RECOMMENDATION MEETING

3435 15th Ave W  
Seattle, WA 98119

3040787-LU  
3040822-EG

09.04.2024

CHANGE TO DESIGN PROPOSAL

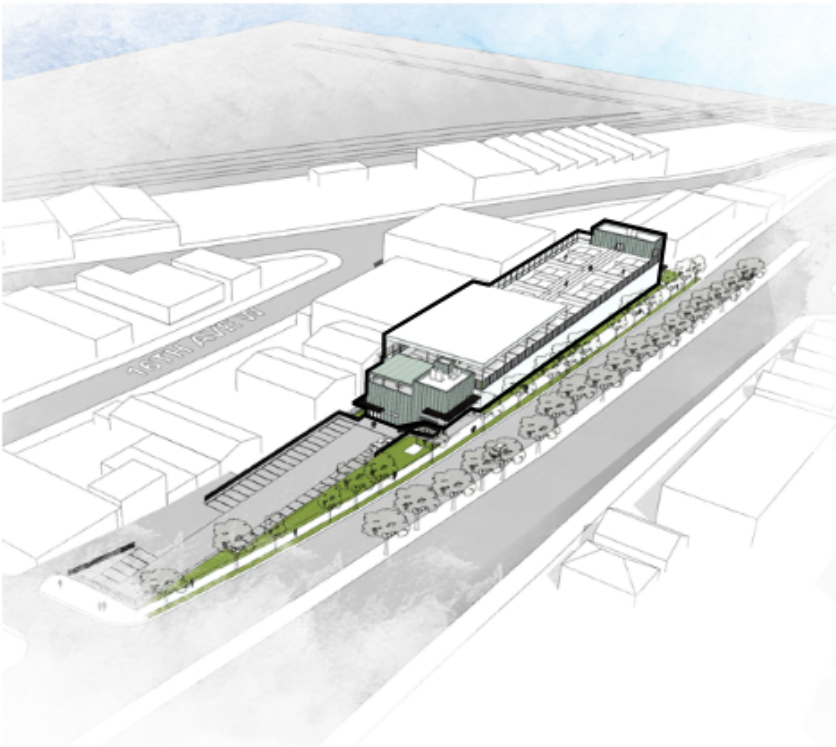
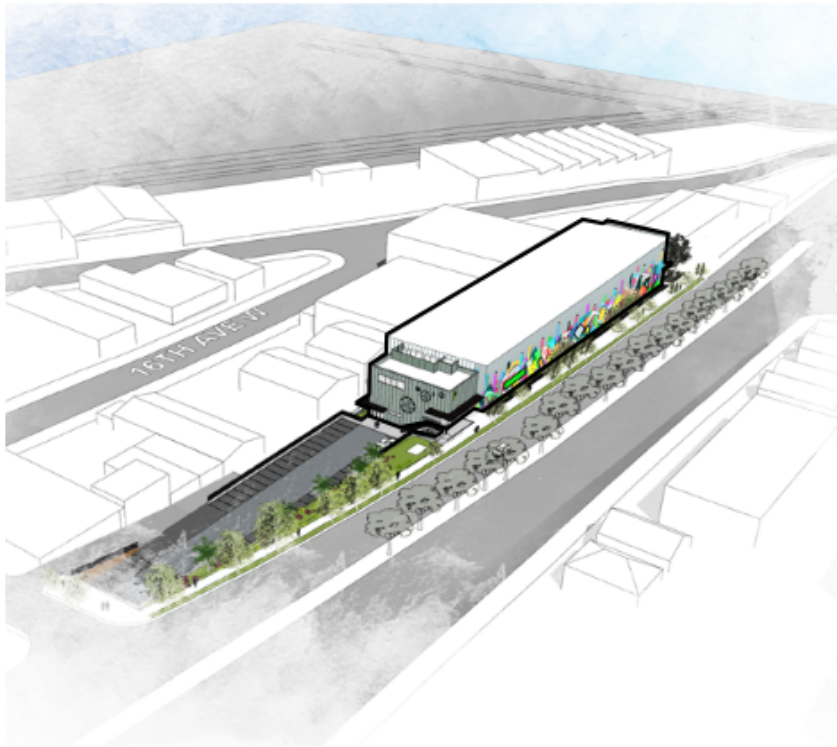
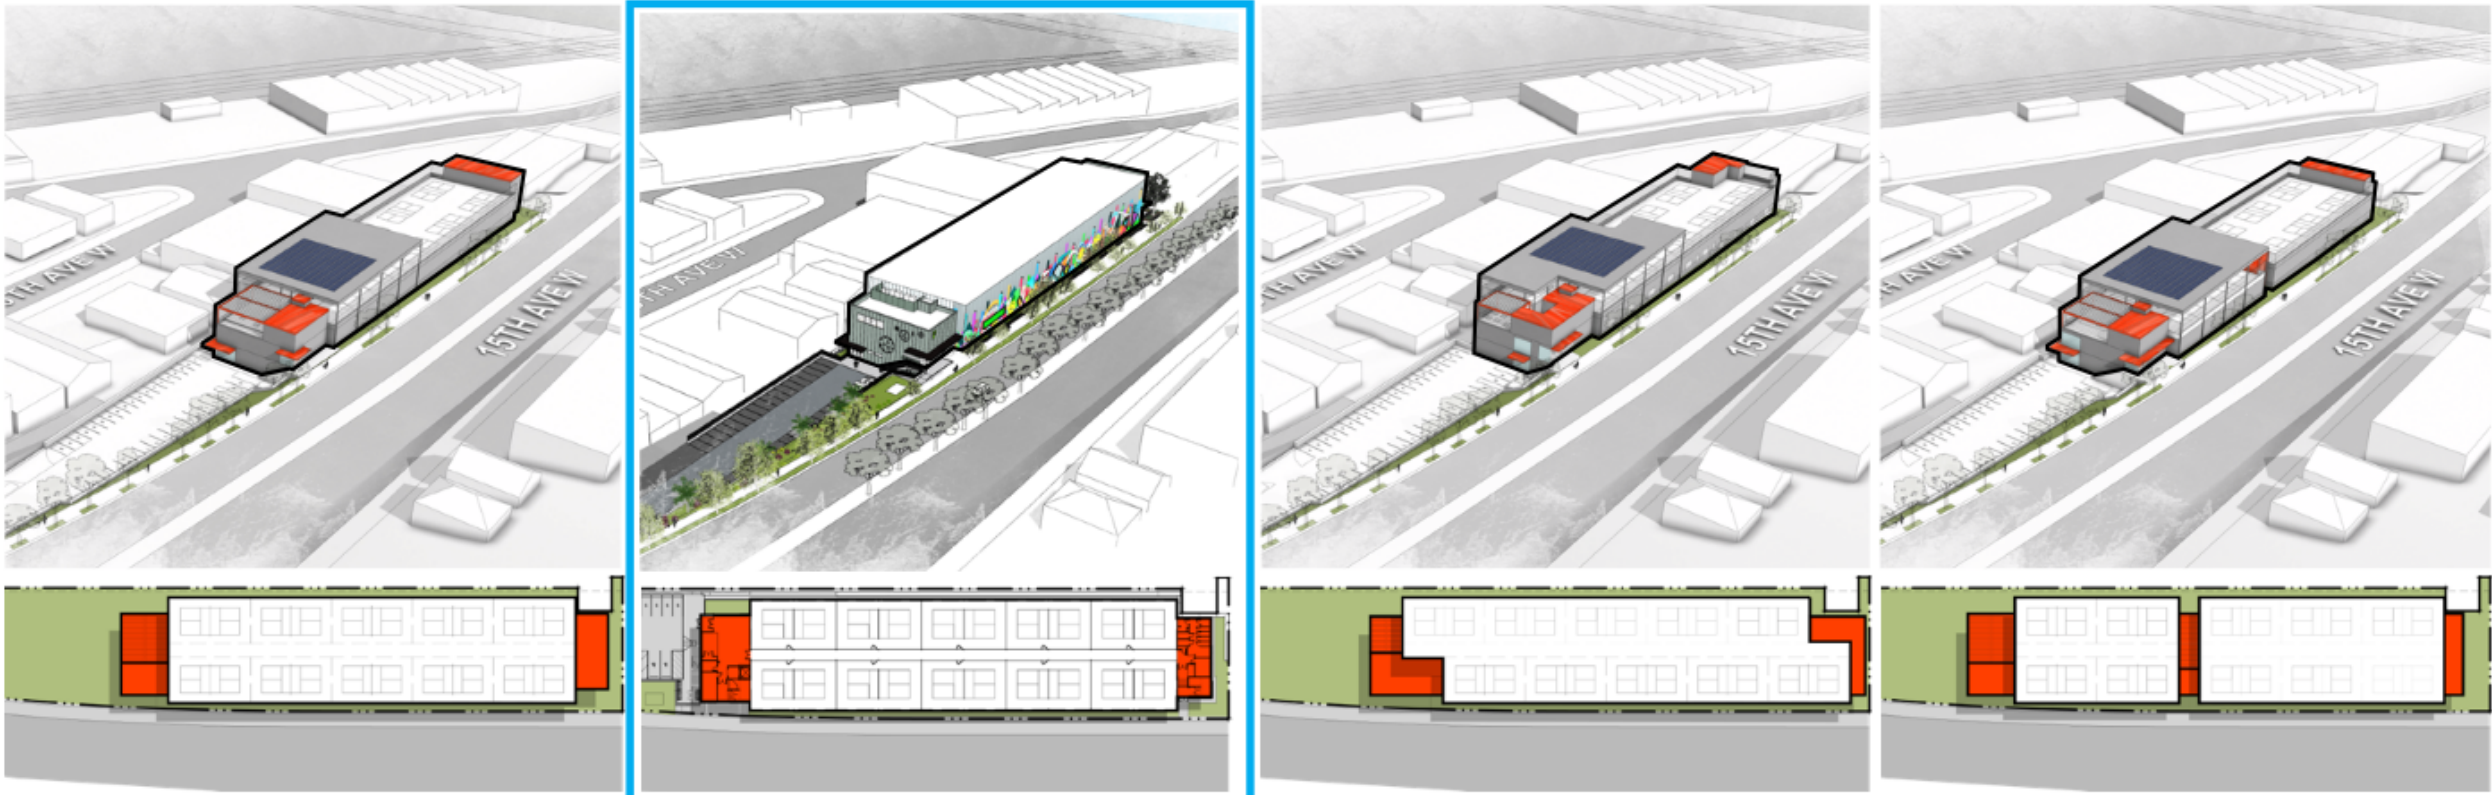
The Board discussed the 3 massing options, noting that though option 3 provides the most massing relief, it is also the longest building. Overall, the Board supported the applicant’s preferred option 1 as this option most responded to site conditions and the form reflected the proposed use. However, the Board stressed the need to further develop the façade design to better provide visual interest and breakdown of this long façade. (DC2-A Massing, DC2-B Architectural and Facade Composition, DC2-A-1. Site Characteristics and Uses, DC2-E Form and Function)

Noted. The design has proceeded with the preferred option with the upper courts now fully enclosed.

FIGURE 1: EVOLUTION OF EAST FACADE DESIGN

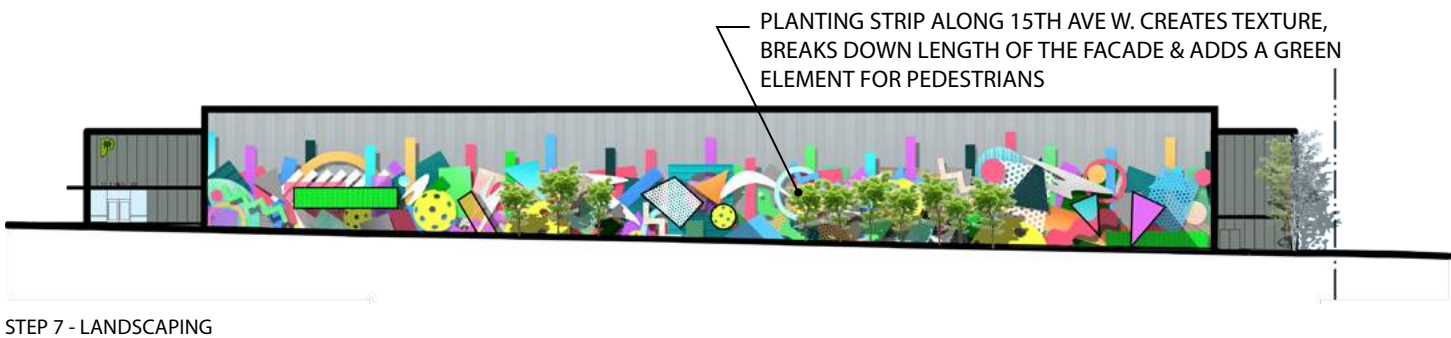
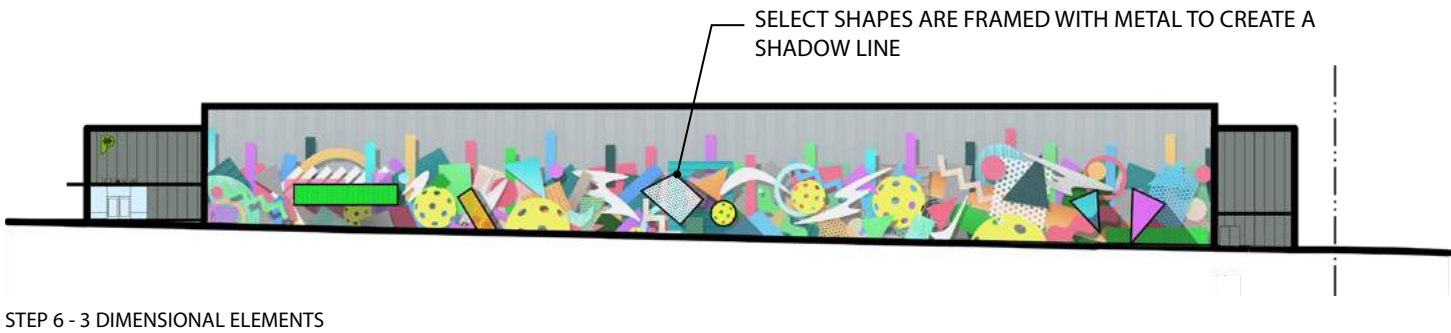
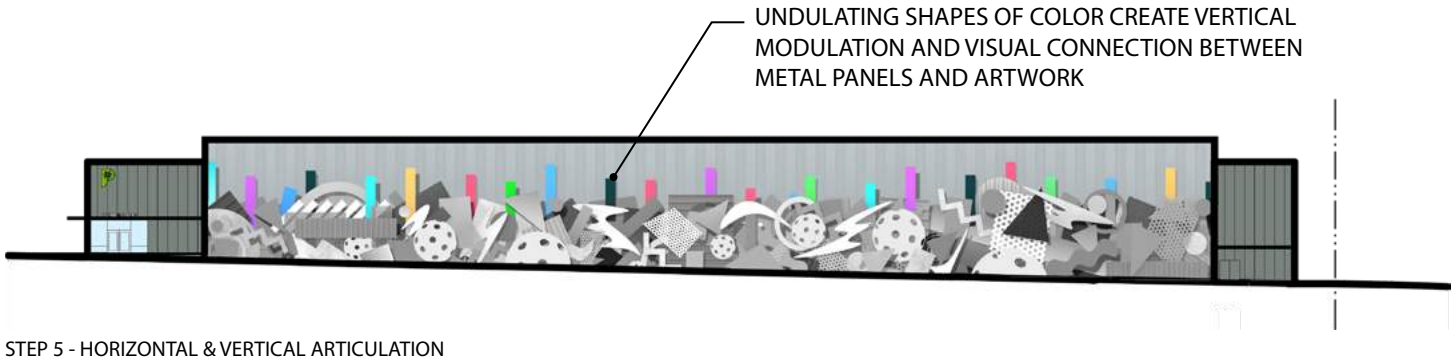
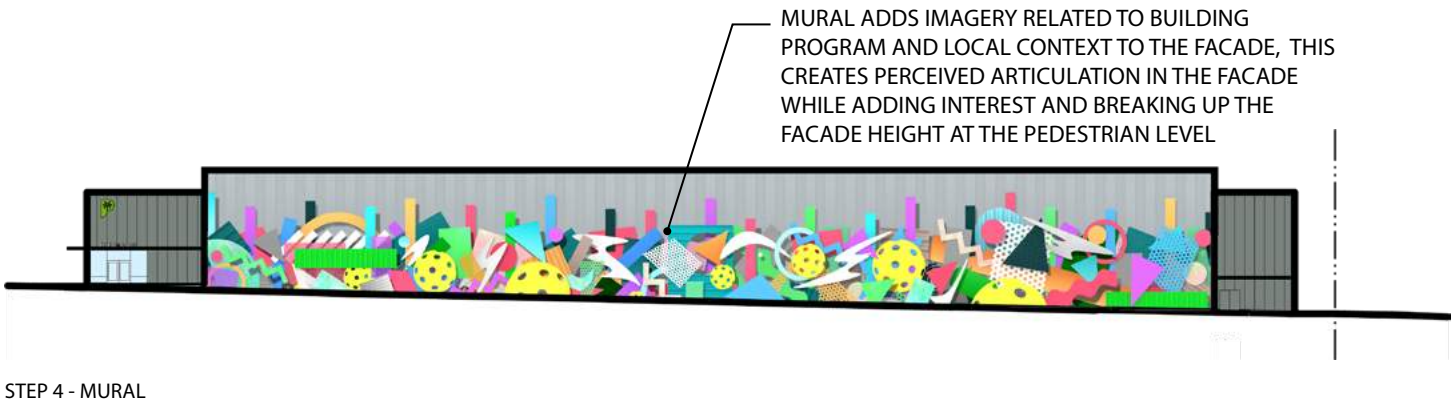
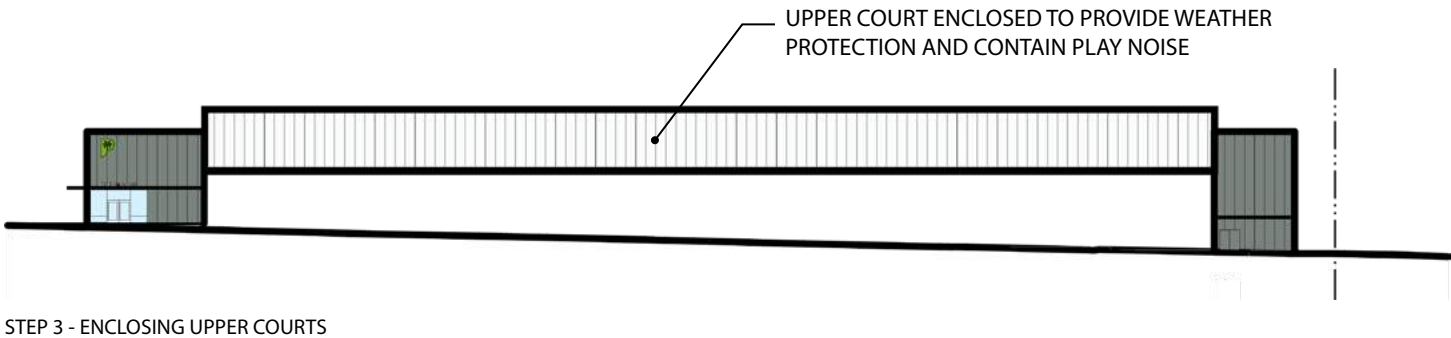
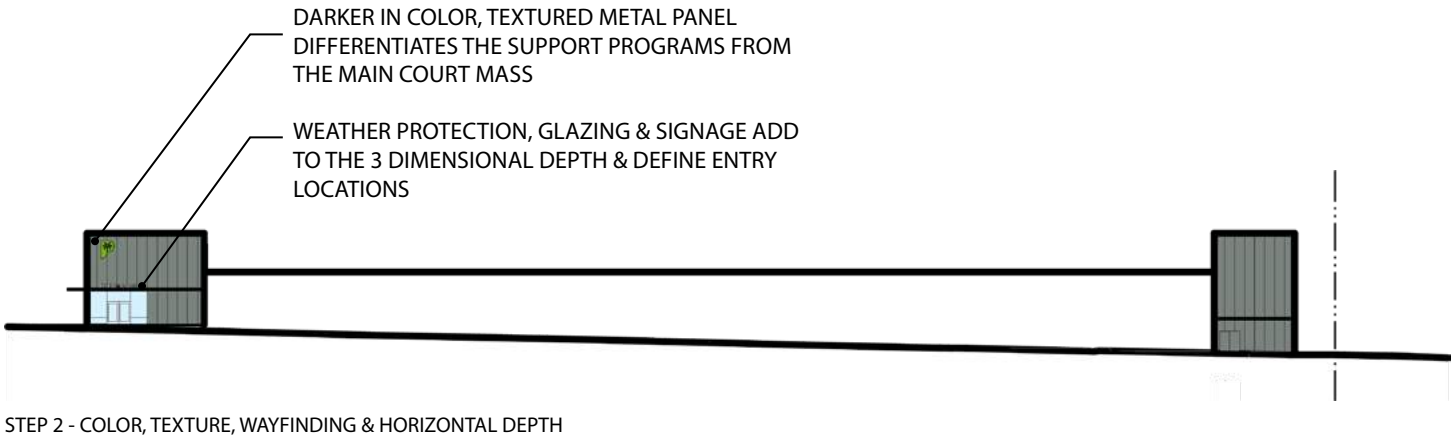
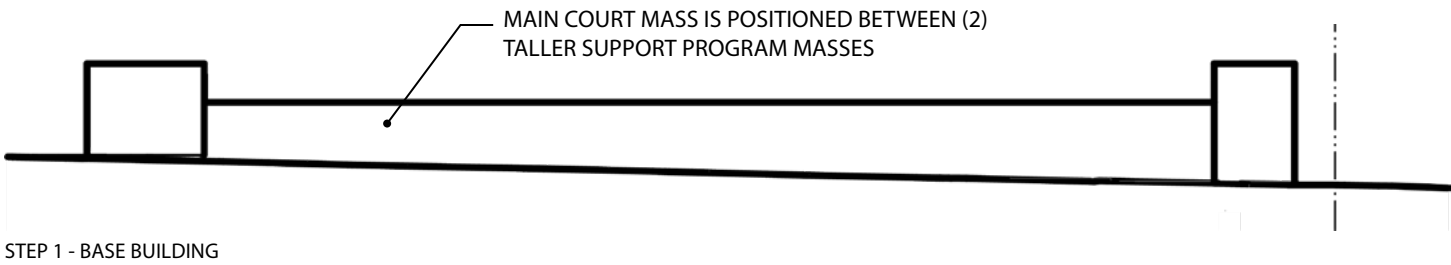
i. The Board supported the concept of integrating mural along the 15th Avenue W façade, however stressed the need to also utilize materials with texture and depth to provide further visual interest and breakdown the appearance of the long blank façade. (CS2-A-2. Architectural Presence, DC2-C Secondary Architectural Features, DC2-B Architectural and Facade Composition, DC2-D Scale and Texture, DC4-A Exterior Elements and Finishes)

iii. The Board strongly supported the potential of a screening element coming down from the roof top canopy. Would like to see this continue and further refined as the design evolves. The Board further suggested the mural and/or signage could be integrated here to further create a secondary architectural moment. (CS2-A-2.Architectural Presence, DC2-C Secondary Architectural Features, DC2-B Architectural and Facade Composition, DC2-D Scale and Texture, DC4-A Exterior Elements and Finishes, DC4-B Signage)

- The 15th Ave W façade length is first broken up by utilizing a different metal panel color on the north and south masses from the main court mass.
- Canopies & glazing provided texture, depth and clearly defined entry points.

- Mural is proposed on the east façade of the court mass along 15th Ave W. The proposed mural serves many purposes including:
  - Creates visual interest both at the pedestrian street level and from distance.

- Creates texture and depth by the design of the artwork with overlapping layers of objects and shadows.
  - Creates a dynamic façade with the design depicting movement of pickleballs along the façade length.

- Identifies the building’s use as a pickleball sports center.
  - Ties in the enclosed upper courts by utilizing random vertical undulating strips of colors. The verticals help create horizontal & vertical articulation, provide rhythm, and break up the façade’s length and height.

To address the strong market feedback, as well as the noise issue associated with pickleball play, the proposed design encloses the upper courts. This move contains any pickleball play noise as well as provides an opportunity to tie in the proposed mural to the upper courts facade. This is done by utilizing random vertical undulating strips of colors. In combination with the lighting, this creates an added layer on the façade and fun visual interest, as well as breaks up the facade length and height.

FIGURE 2: TYPICAL STREET SECTION ALONG 15TH AVE. W.

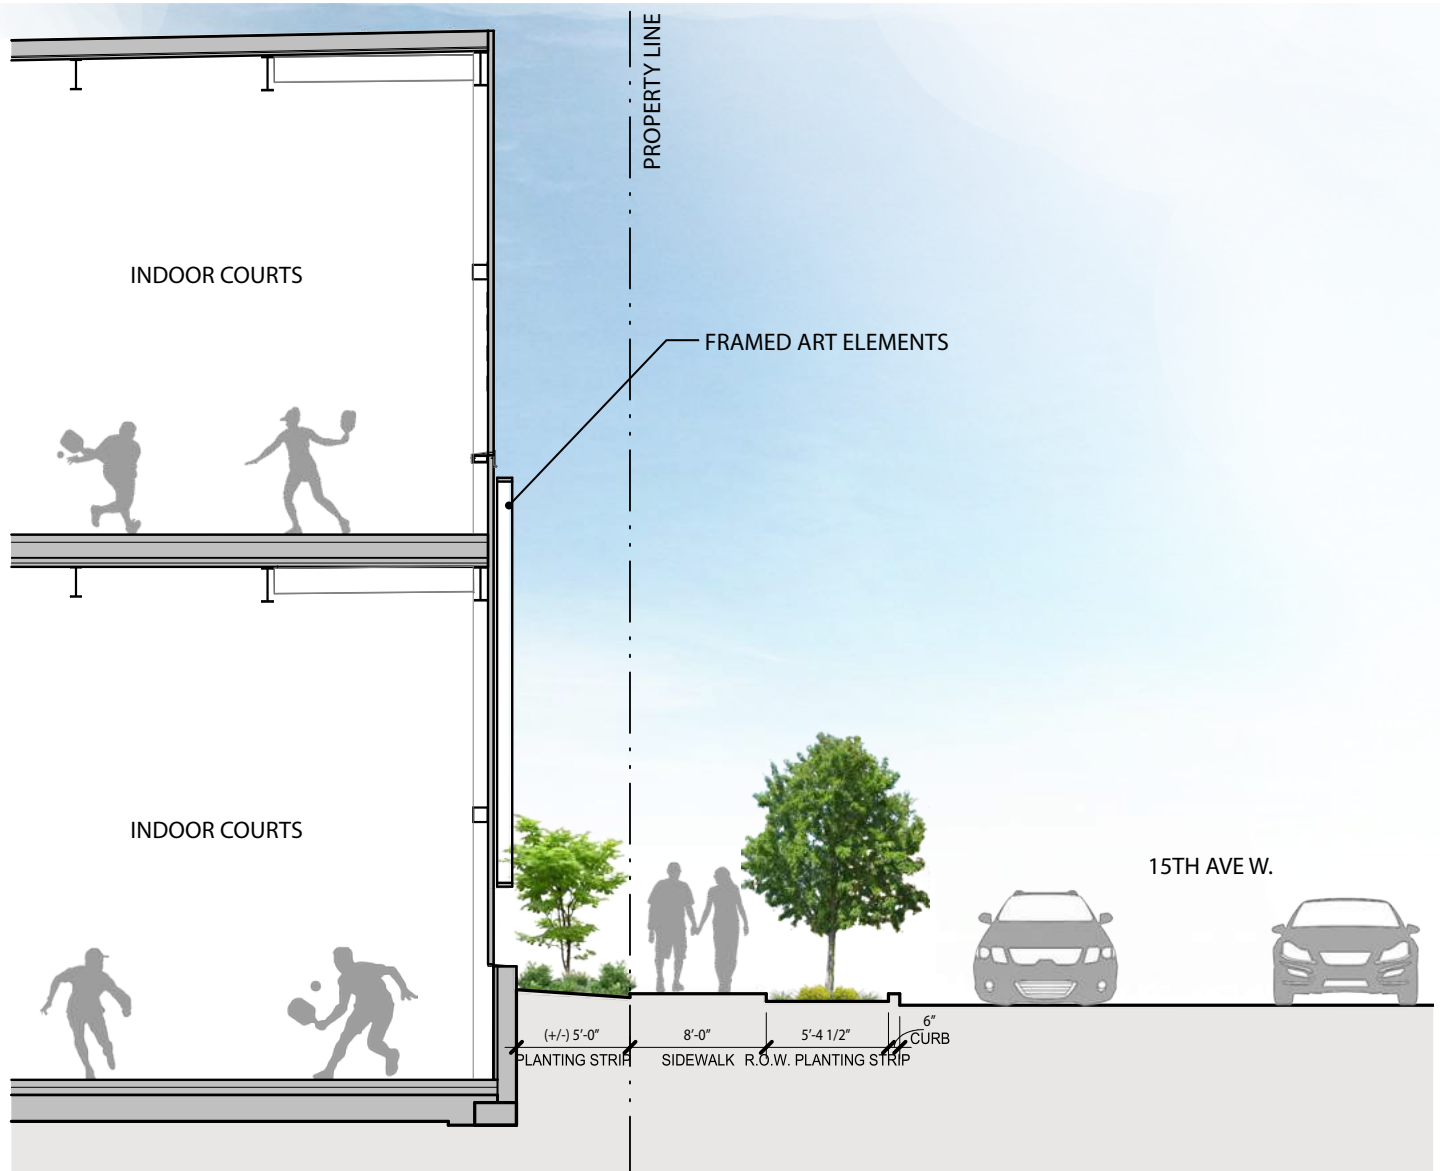
The Board acknowledged public comment regarding pedestrian movement and connection, providing guidance to further clarify at Recommendation how the building's access tied into the larger pedestrian connection and circulation surrounding the project site. (DC1-A Arrangement of Interior Uses, PL3-A Entries, PL1-B Walkways and Connections)

- 16th Ave W. is currently a main pedestrian street in the area. The improved sidewalk along the site's W Bertona St frontage will connect pedestrians from 15th Ave W. to this street.

- The new sidewalk along the 15th Ave W. frontage of the site will be improved with new planting strip and street trees. The mural on the façade along the sidewalk, as well as landscape strip and new on-site trees, will enliven the streetscape, encouraging more pedestrian traffic in the area.

- The main entry from parking area is clearly visible from W Bertona St and the exit/secondary entry is provided from 15th Ave W. Both streets will be activated by the presence of this pickleball facility and its users.

- There is a median on busy 15th Ave W that extends from Gilman Dr on the south, extending north past the Ballard bridge. The only way for pedestrians to walk from east to west is at the Dravus overpass. Pedestrian traffic is limited to north/southbound on the west side of 15th Ave W.
